STATE OF NORTH CAROLINA
DEPARTMENT OF TRANSPORTATION

July 9, 2004

SUBJECT: Permit Modification Request for TIP No. U-2527, Vance County, Western Outer Loop from SR 1128 (Ruin Creek Road) to SR 1101 (Old County Home Road) near Henderson, Federal Aid No. STP-0509(2), State Project No. 8.2390201, NCDOT Division 5, \$475 Debit WBS Element 34822.1.1.

The purpose of this letter is to request modifications to the CWA Section 404 Individual Permit issued by the USACE, the 401 Water Quality Certification issued by the NC Division of Water Quality (DWQ), and Riparian Buffer Certification issued by DWQ. Revised permit drawings are attached. A revised natural stream design plan is also attached.

SHEET 11 OF 41

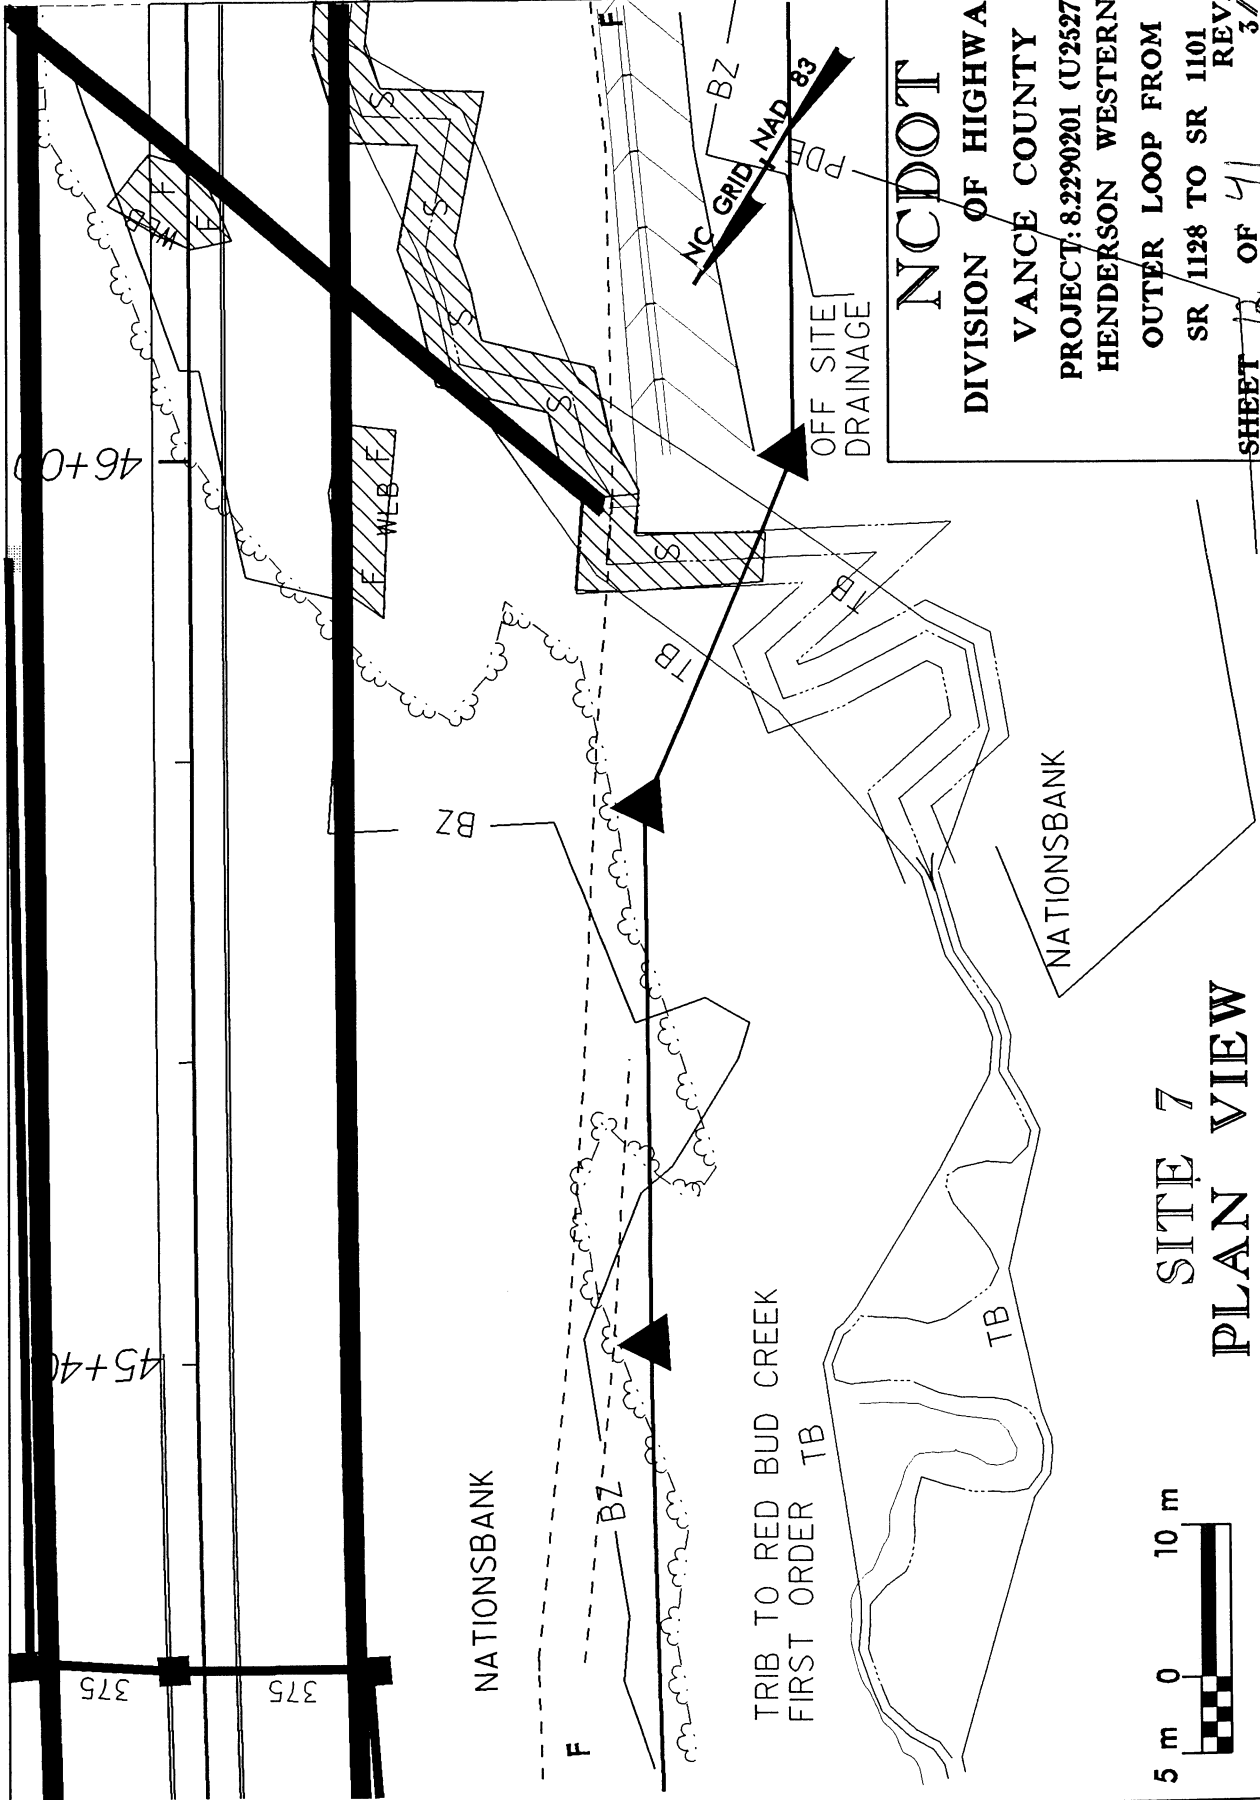
- Stream site 6, buffer site 8 (permit drawing 11 and 30, plan sheet 12, erosion control sheet EC-13, Station 40+81)

Issue: The plan sheet depicts Structure 92 at Station 40+39 Rt and Structure 93 at Station 40+59 Rt. These structures are not depicted on the permit drawing.

Issue: The plan sheet depicts a Preformed Scour Hole (PSH) located outside of the riparian buffer at Station 40+90 Rt. This PSH is located inside of the riparian buffer on the permit drawing.

Issue: The tie in points of the temporary channel change as depicted on EC-13 are located outside of the permitted stream and buffer footprint as depicted on the permit drawing.

Issue: There are slight discrepancies in the depiction of the fill slopes in the northeast, northwest and southwest quadrants between the permit drawing and the plan sheet.

Issue: The plan sheet indicates the presence of rip rap at the inlet and outlet of the structure. The impact associated with the rip rap is not entirely depicted as buffer impacts on the permit drawing.

Status: The permit drawing has been modified to depict structures, the correct location of the PSH, revised stream impact, revised buffer impact, additional buffer impact and the correct fill slope. **This resulted in an increase of stream impact of 9.9 ft.**

SHEET 13 OF 41

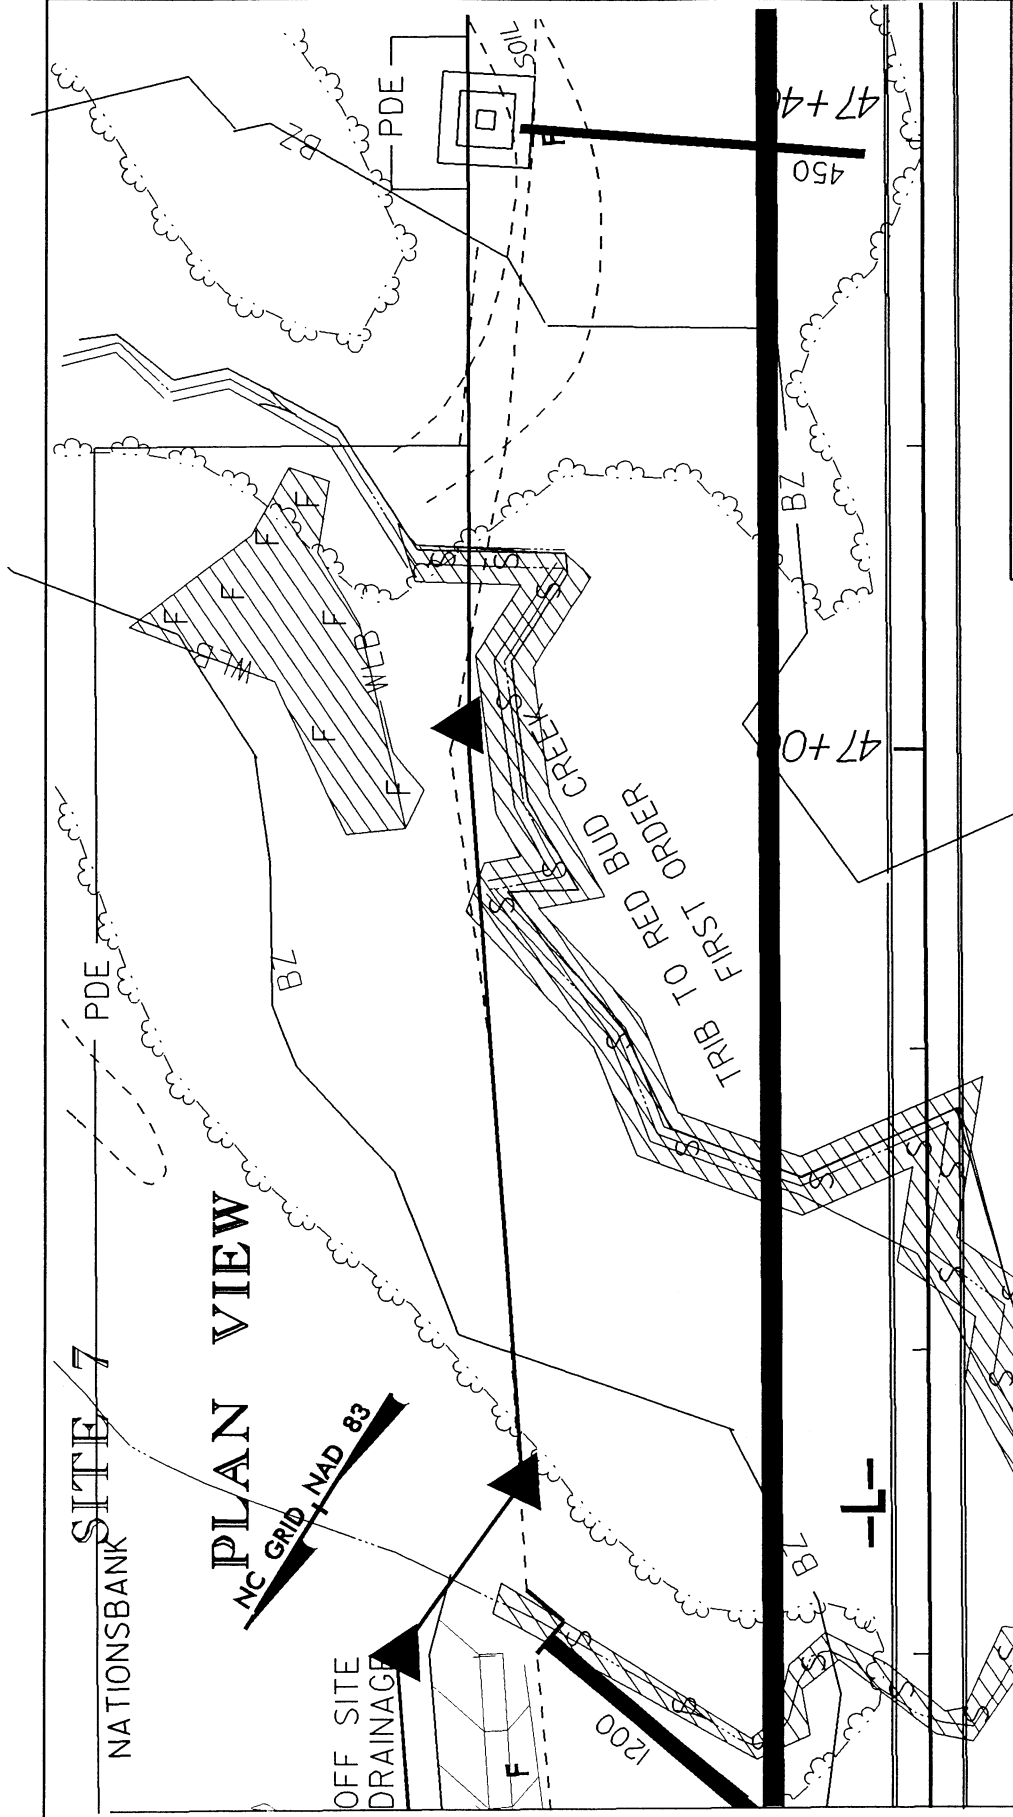
- Stream site 7, buffer site 9 (permit drawing 12, 13, 31, and 32, plan sheet 14, Station 46+20)
Issue: The plan sheet depicts a lateral base ditch through the riparian buffer at Station 46+10 Rt. This lateral base ditch is not depicted on the permit drawing.
Issue: The plan sheet depicts a lateral base ditch at Station 46+30 Lt. This lateral base ditch is not depicted on the permit drawing.
Issue: The plan sheet depicts a 450mm cross pipe and an associated PSH at Station 47+40. The cross pipe and PSH are not depicted on the permit drawing.
Issue: The plan sheet depicts a small portion of the riparian buffer within the mechanized clearing limits of the project at Station 45+40 Rt. This buffer impact is not depicted on the permit drawing.
Status: The permit drawing has been modified to depict the lateral base ditches, cross pipe, additional buffer impact and PSH. **This resulted in an increase of riparian buffer impact of 0.03 ac (1306.8 square ft) in Zone 1 and 0.01 ac (435.6 square ft) in Zone 2.**

BUFFER IMPACTS
SITE 3
PLAN VIEW

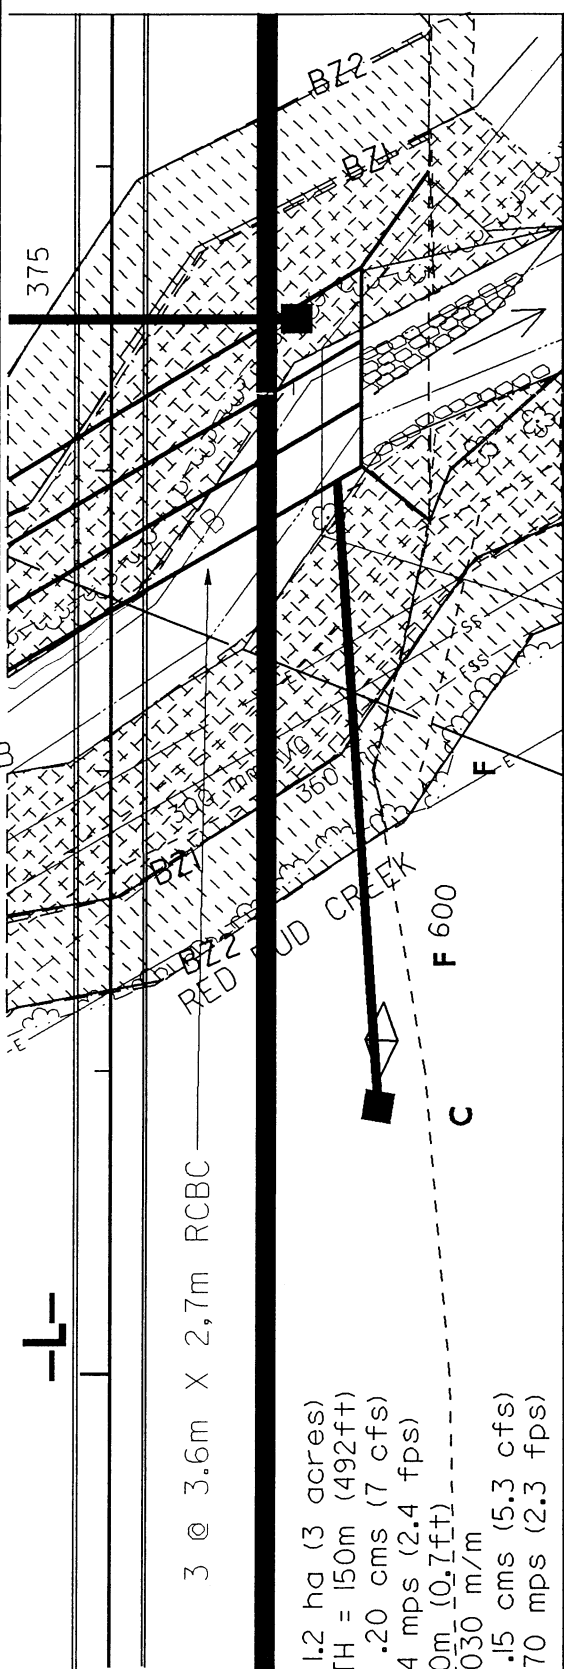
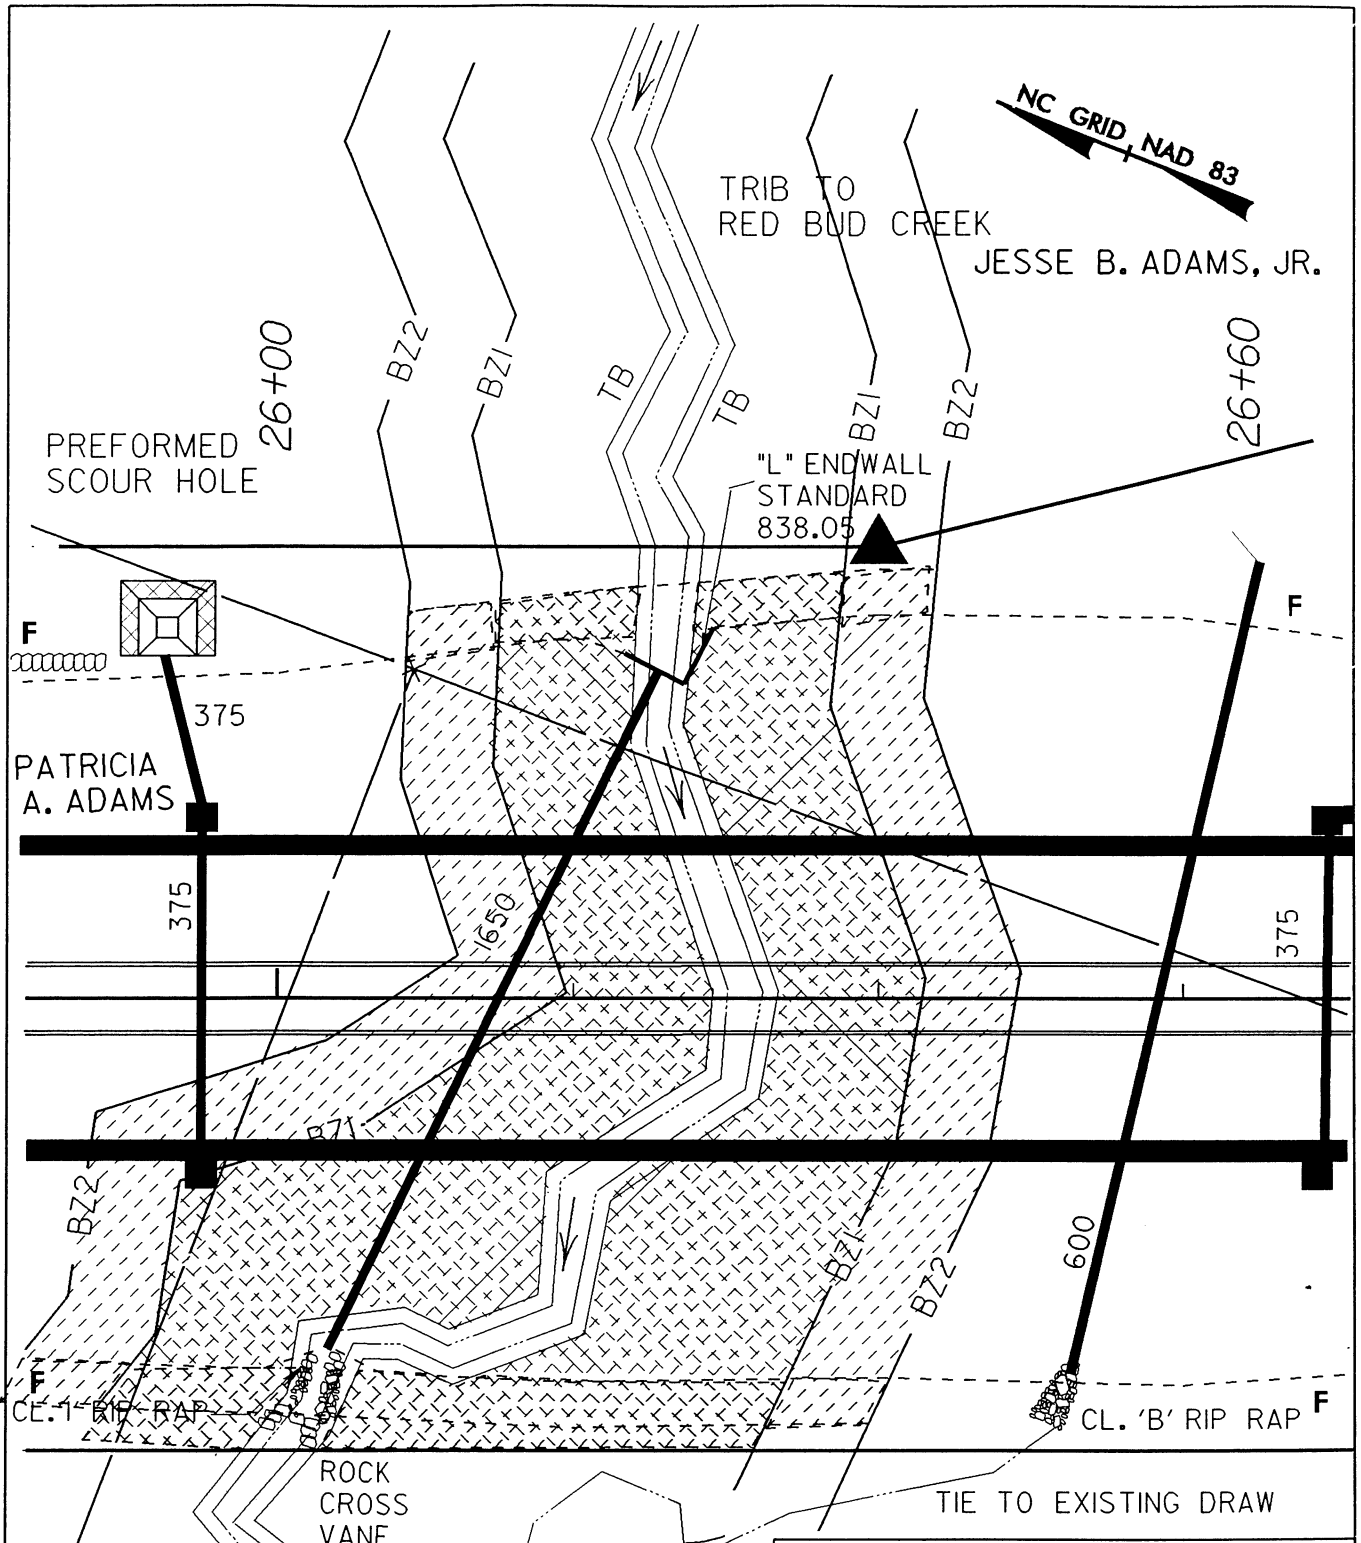
- Stream site 3, buffer site 3 (permit drawing 7, 24, and 25, plan sheet 7, Station 23+40)
 Issue: The plan sheet indicates the presence of rip rap along the northern streambank immediately upstream of the relocated channel at the inlet of the culvert. This rip rap is not depicted on the permit drawing.
 Issue: The plan sheet indicates the presence of a relocated channel, rip rap and a lateral base ditch immediately upstream of the inlet of the culvert. These impacts are not depicted on the permit drawing.
 Issue: The plan sheet indicates the presence of rip rap immediately downstream of the outlet of the culvert. The impact associated with this rip rap is not entirely depicted as a buffer impact on the permit drawing.
 Issue: There is a discrepancy in the depiction of the western fill slope between the permit drawing and the plan sheet.
 Status: The permit drawing has been modified to depict rip rap along the streambank, the additional buffer impacts and the correct fill slope. **This resulted in an increase**

of stream impact of 0.02 ac and an increase of riparian buffer impact of 0.03 ac (1306.8 square ft) in Zone 1 and 0.03 ac (1306.8 square feet) in Zone 2.

NCDOT
DIVISION OF HIGHWAYS
VANCE COUNTY
PROJECT: 8.2290201 (U2527)
HENDERSON WESTERN
OUTER LOOP FROM
SR 1128 TO SR 1101
SHEET 29 OF 41
 REV. 06 / 04
 3 / 16 / 02

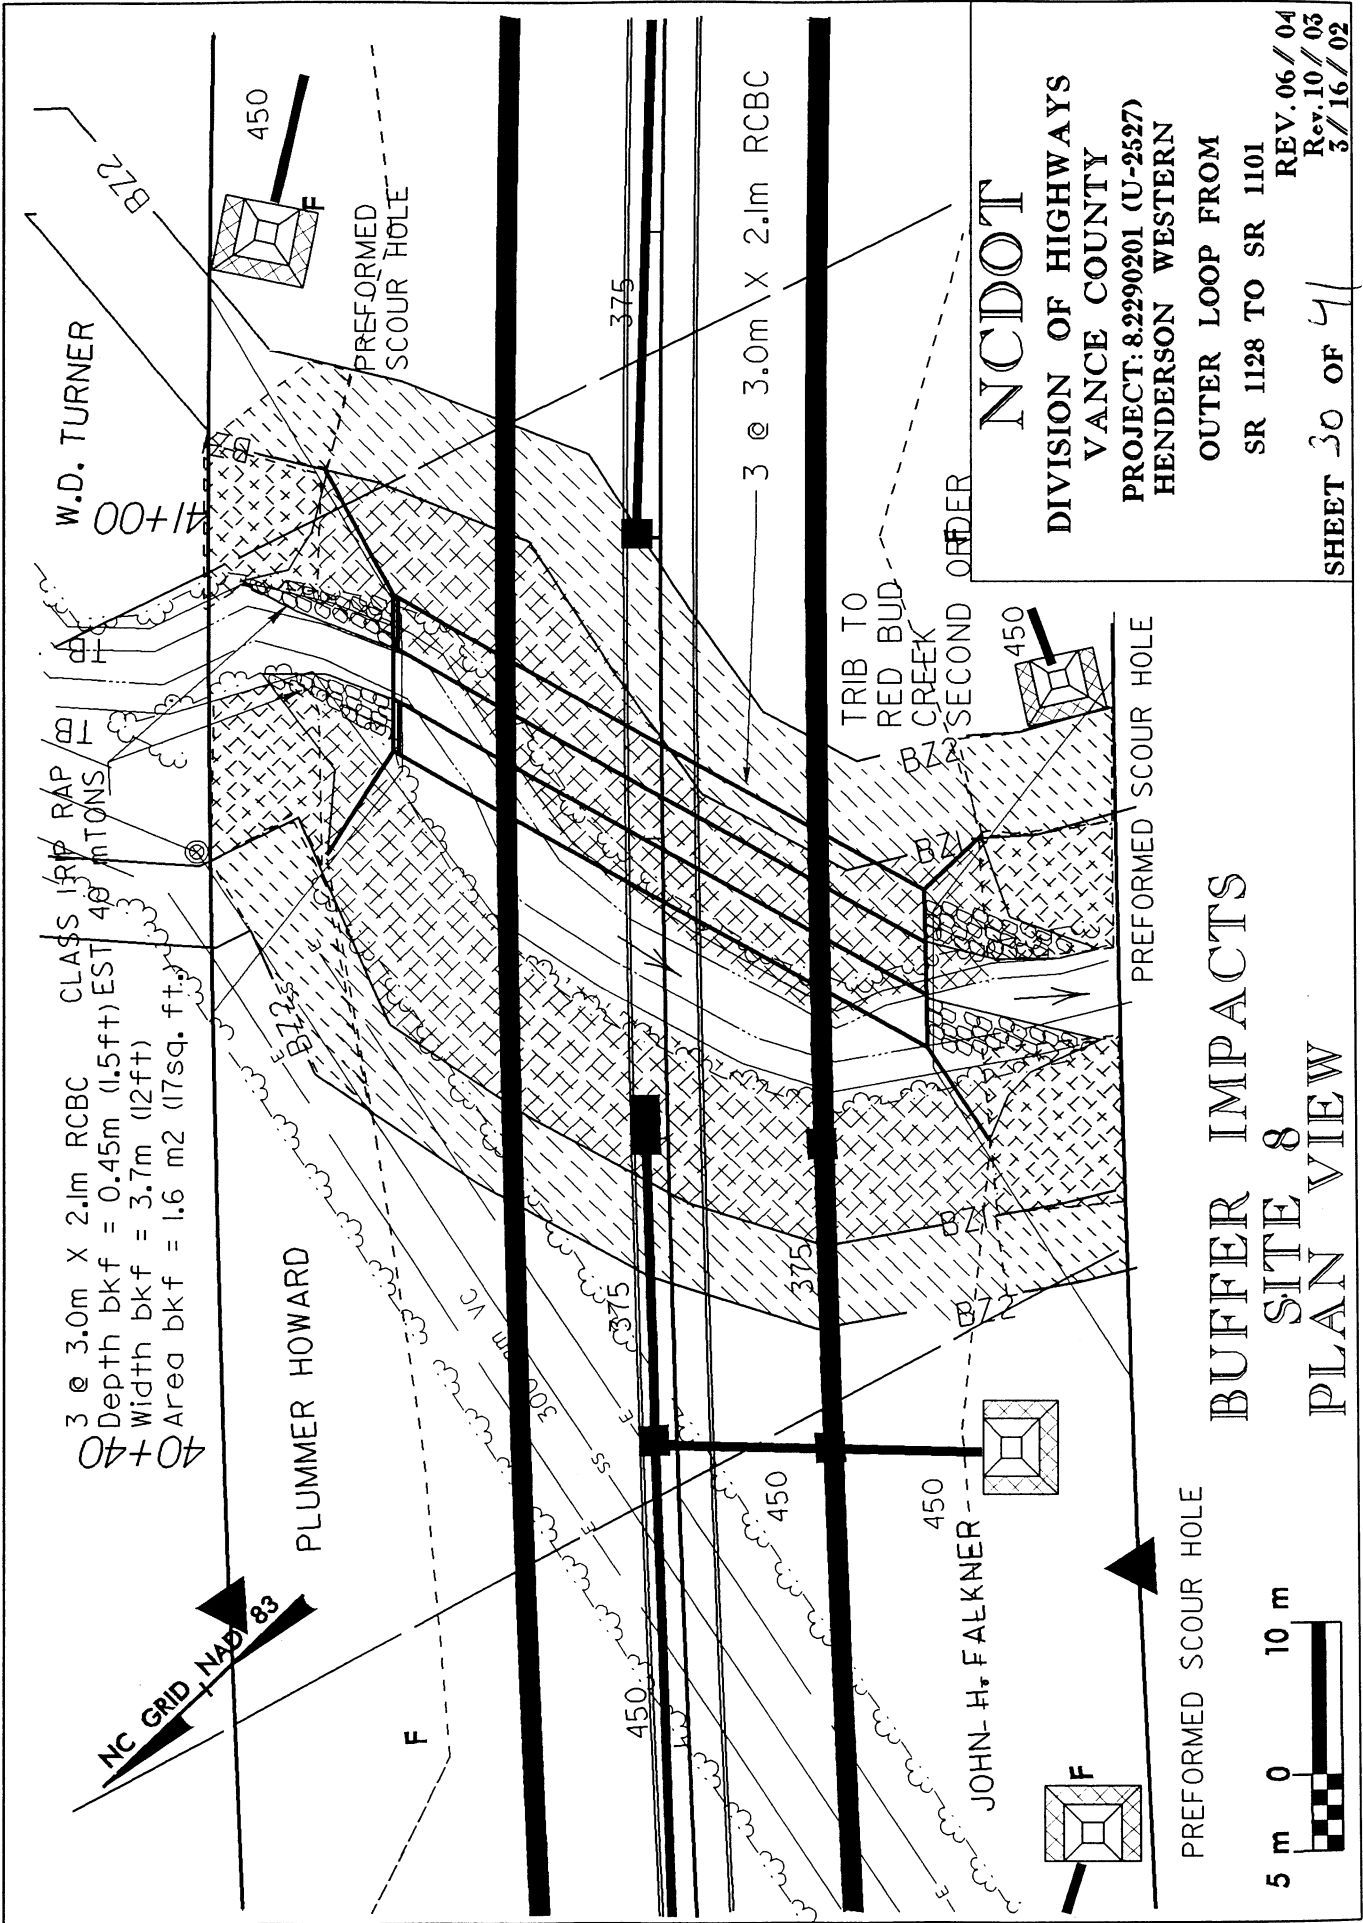
- Stream site 5, buffer site 7 (permit drawing 10 and 29, plan sheet 11, Station 36+72)

Issue: There is a discrepancy in the depiction of the southern fill slope between the permit drawing and the plan sheet.

Issue: The plan sheet depicts the installation of Class I rip rap along the streambank at the outlet of the cross pipe. The permit drawing depicts Class B rip rap at this location.

Issue: The plan sheet indicates the presence of rip rap at the outlet of the structure and lateral base ditches in the northwest and southwest quadrants. The impacts associated with the rip rap and the lateral base ditches are not entirely depicted as buffer impacts on the permit drawing.

Status: The permit drawing has been modified to depict the correct fill slope, size of rip rap and additional buffer impact. **This resulted in an increase of stream impact of 16.4 ft and an increase of riparian buffer impact of 0.02 ac (871.2 square ft) in Zone 2.**
